DOCUMENT 00 90 00
ADDENDUM

ADDENDUM No.: 2

RE: WESTERN TECHNICAL COLLEGE
KUMM CENTER STUDENT UNION REMODEL
400 N. 6TH STREET
LA CROSSE, WISCONSIN 54601

PROJECT No.: 25041

E100

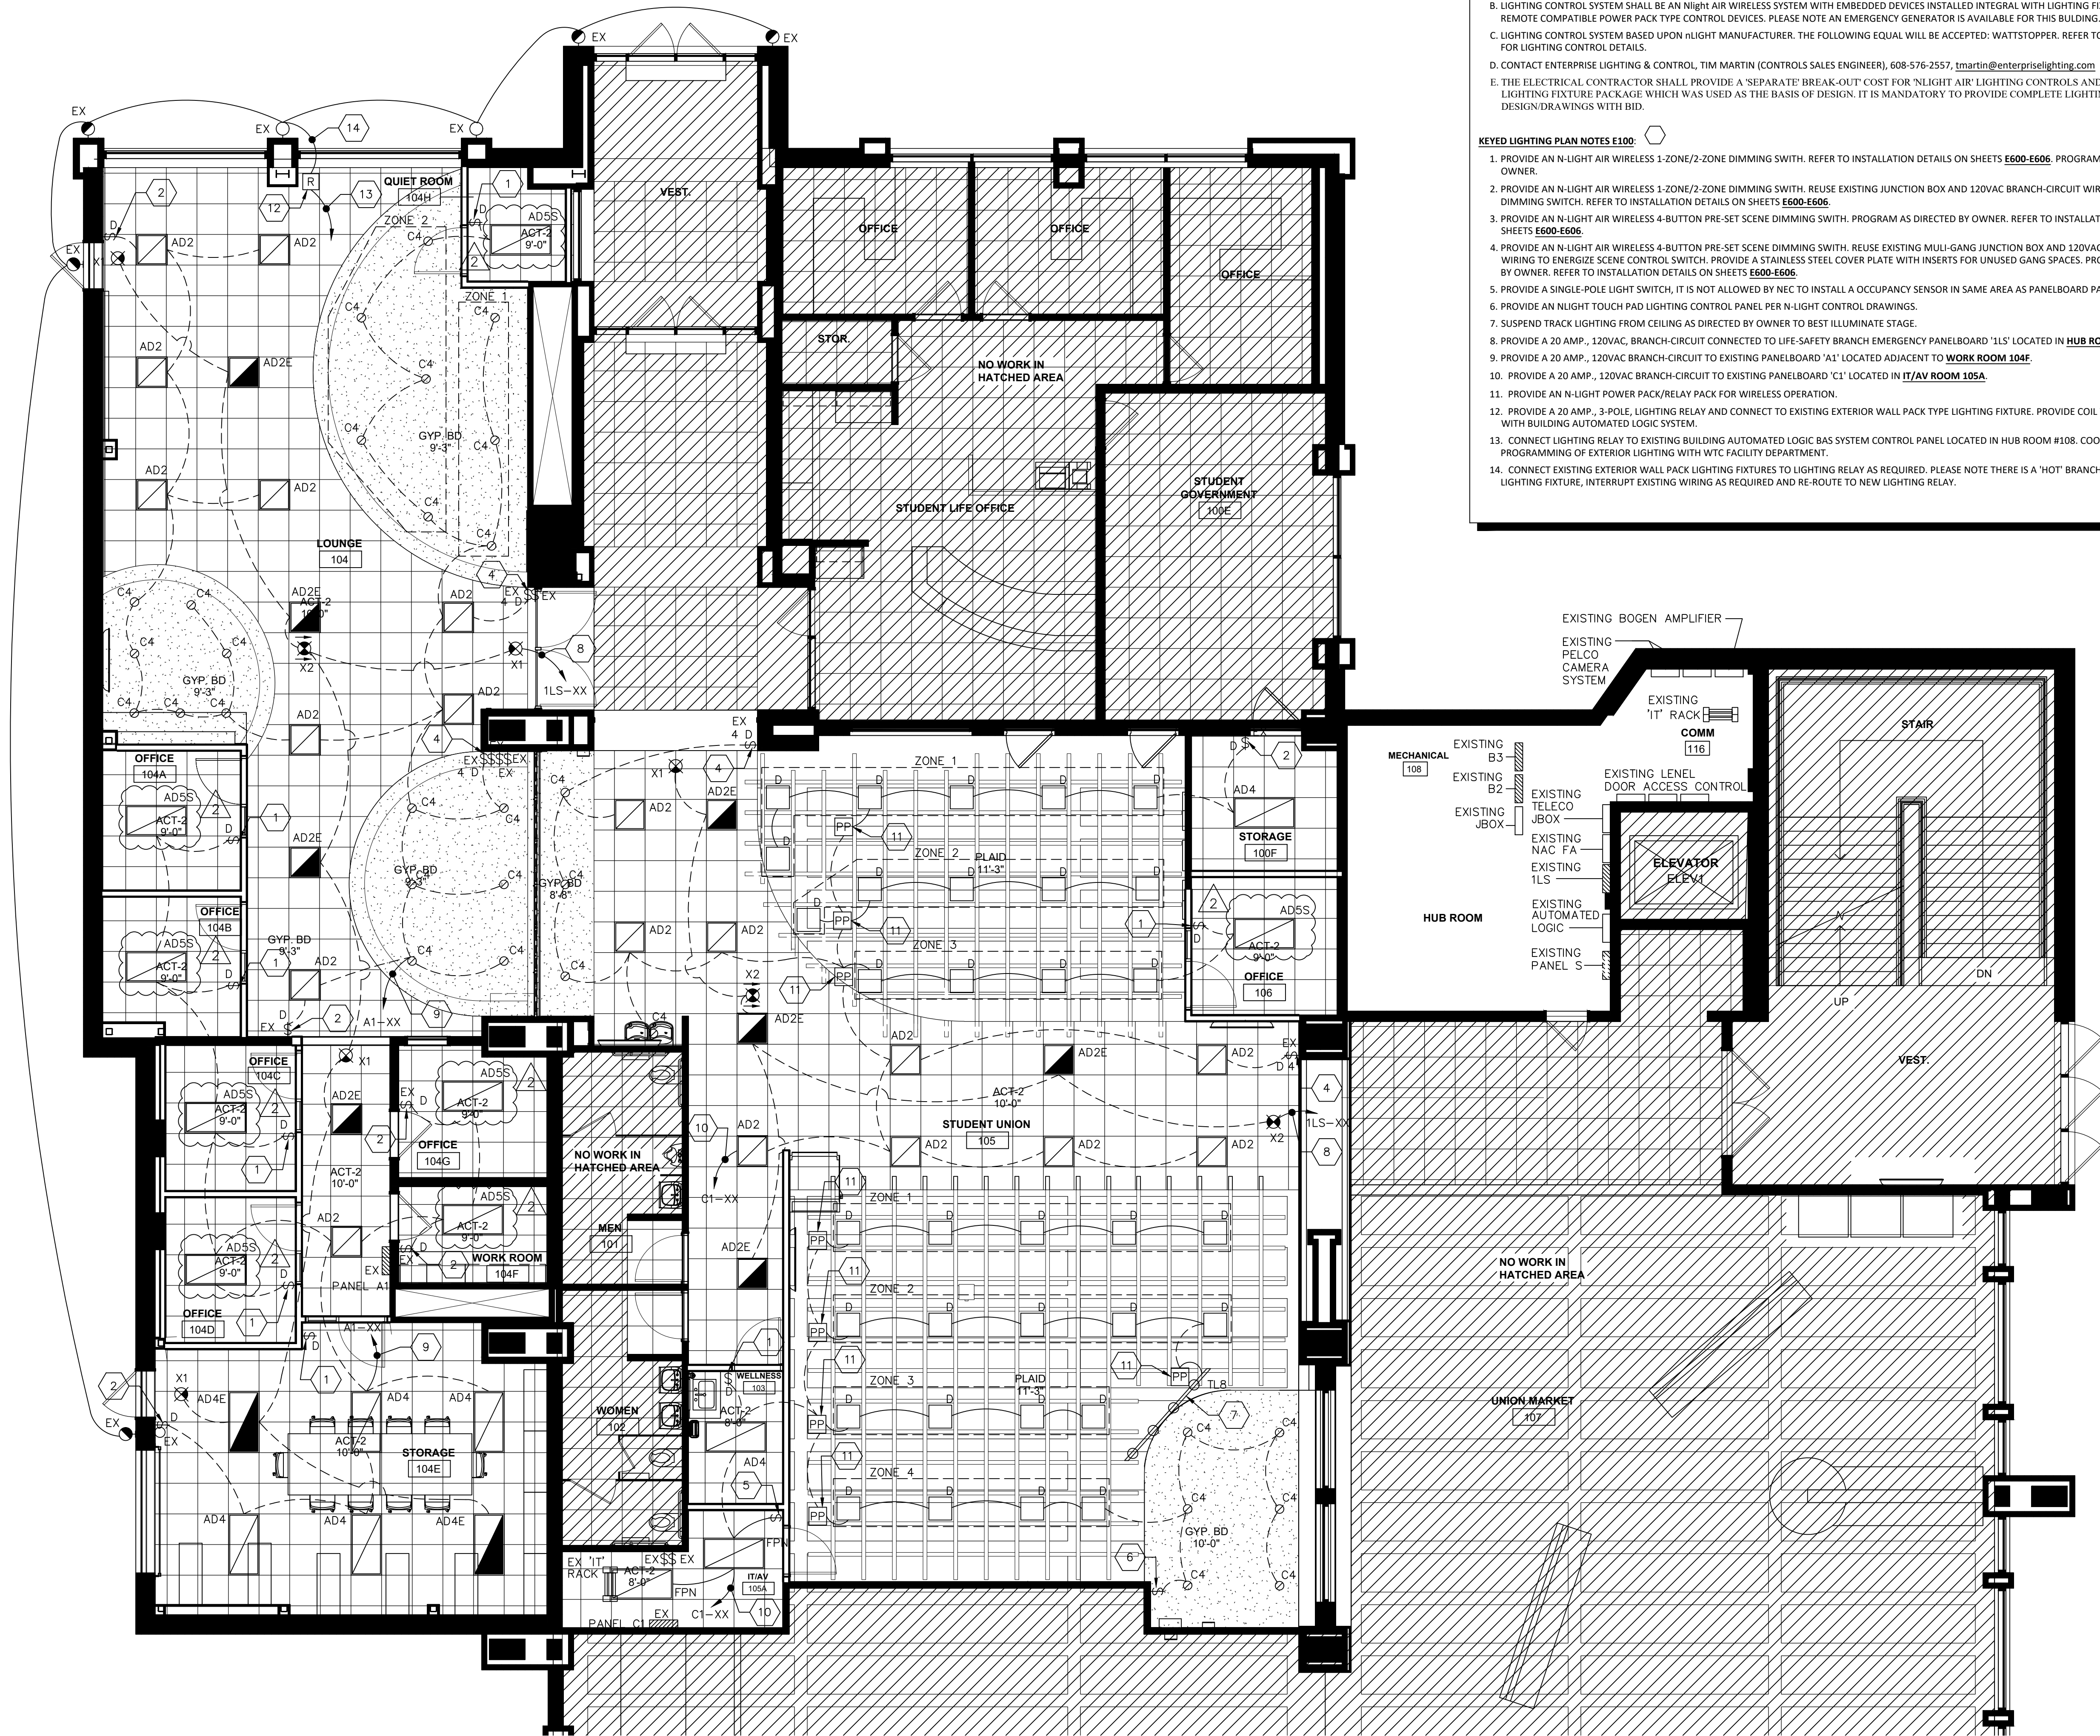
4. Sheet E100 ELECTRICAL LIGHTING PLAN 30"x42"
 - a. See the revised sheet included in this addendum. Disregard the previous version.
 - b. Refer to Offices #104A, #104B, #104C, #104D, #104F, #104G, #104H and #106;

- i. Change light fixture type from AD4 to AD5S. Please note this lighting fixture will change from 5,000 lumens to 6,000 lumens.
5. Sheet E200 POWER PLAN 30"x42"

E200

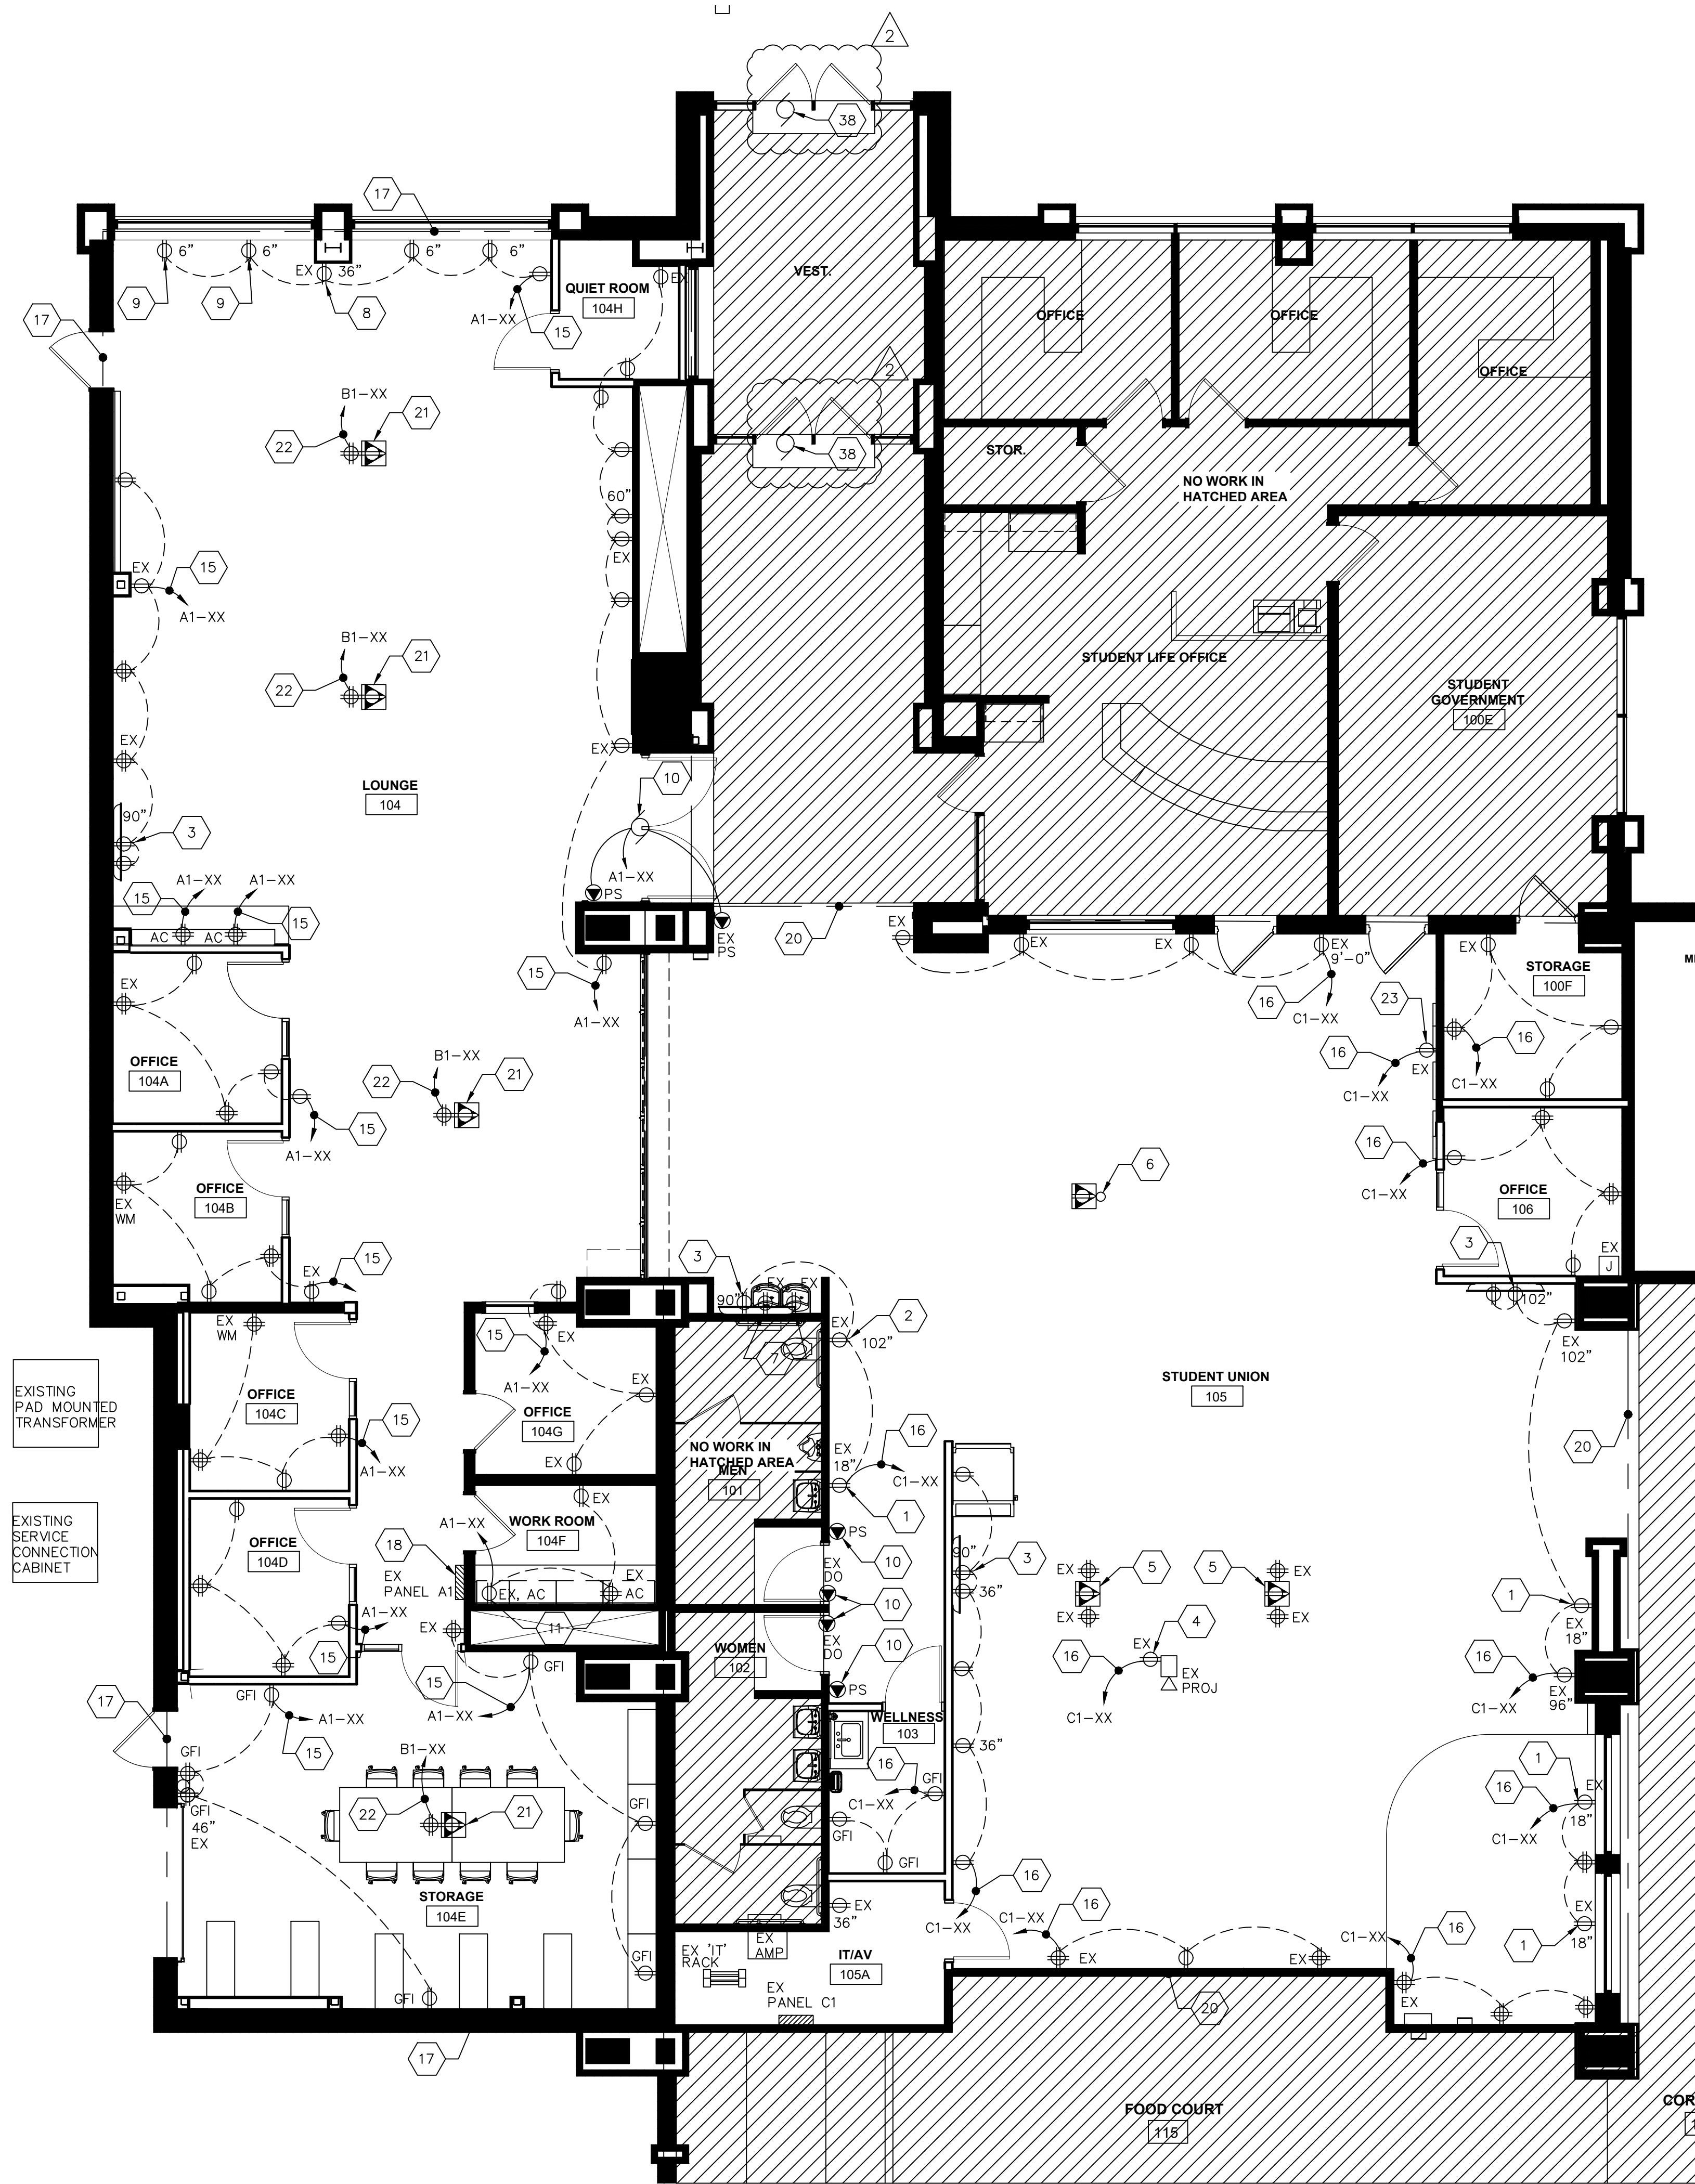
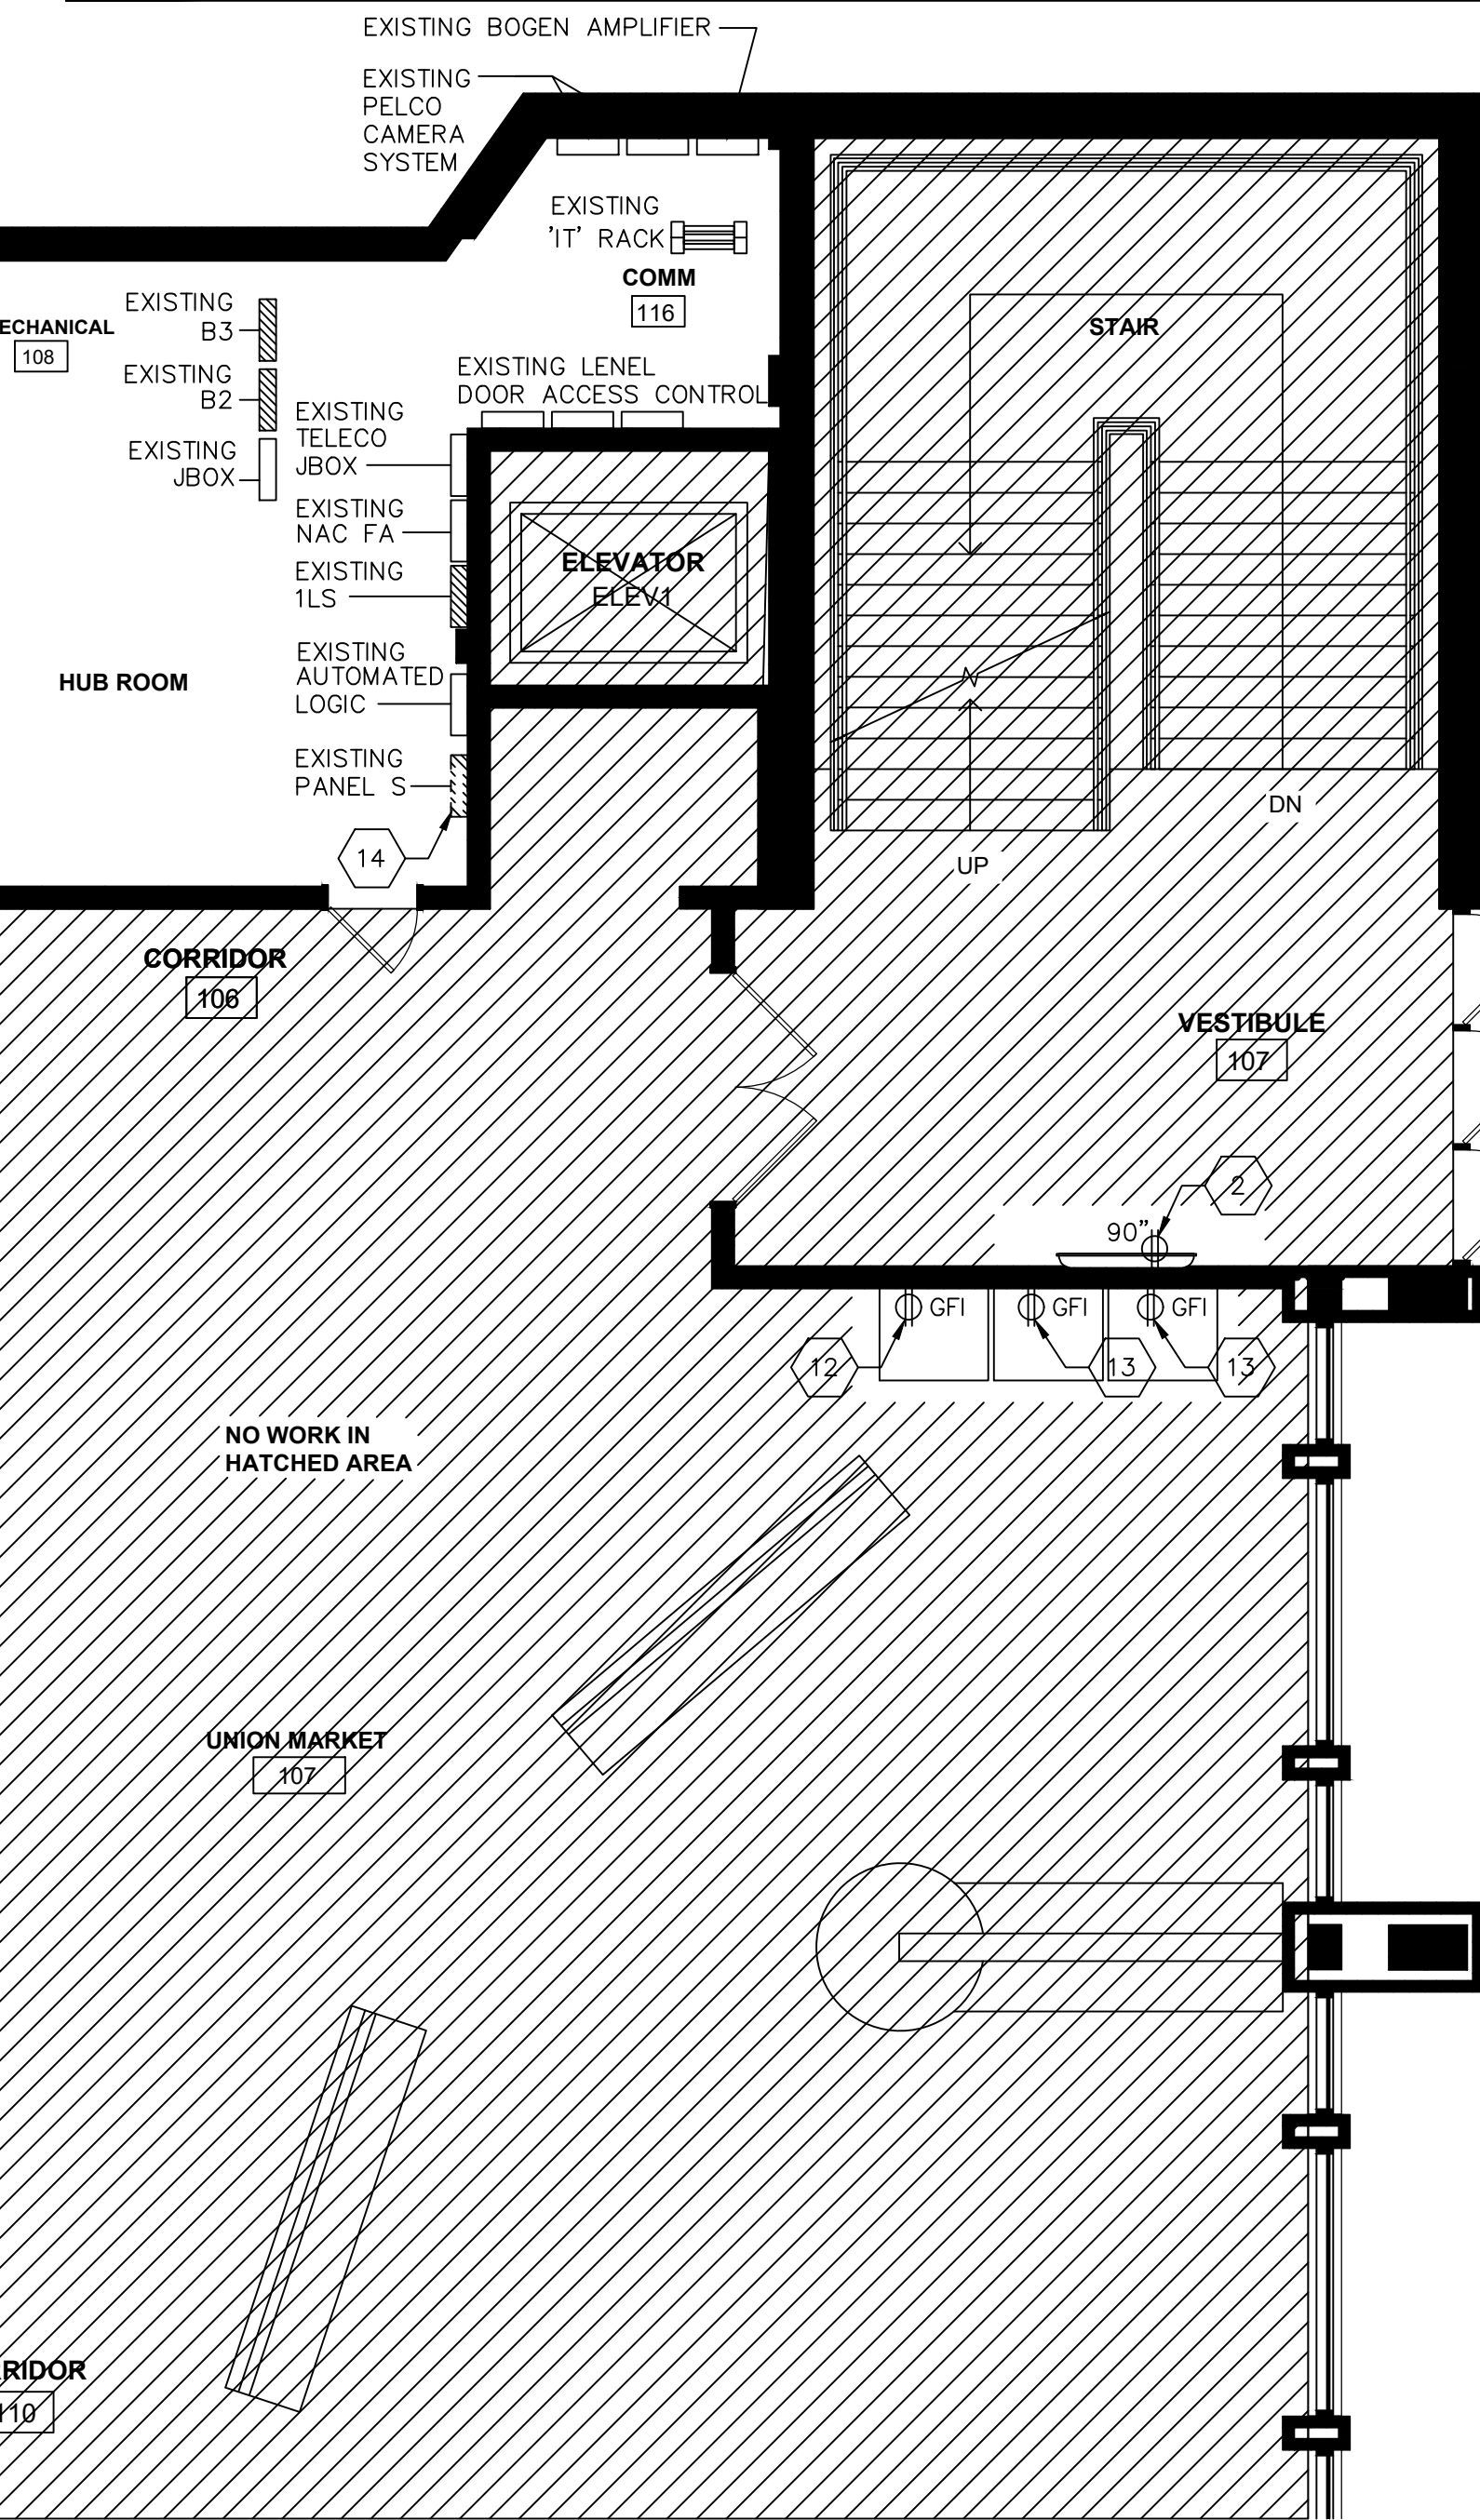
- a. See the revised sheet included in this addendum. Disregard the previous version.
 - b. Refer to Vestibule #101 and Corridor #102;
 - i. Reconnect Two (2) new replacement motorized door openers and associated low voltage control switches on existing doors. Please note, Two (2) motorized door openers were previously disconnected for removal and Two (2) new replacement motorized door openers were installed on existing doors. Reuse existing branch-circuit wiring, low voltage wiring and paddle type control switches. Coordinate with General Contractor, field verify existing conditions prior to submitting bid to determine scope of work.
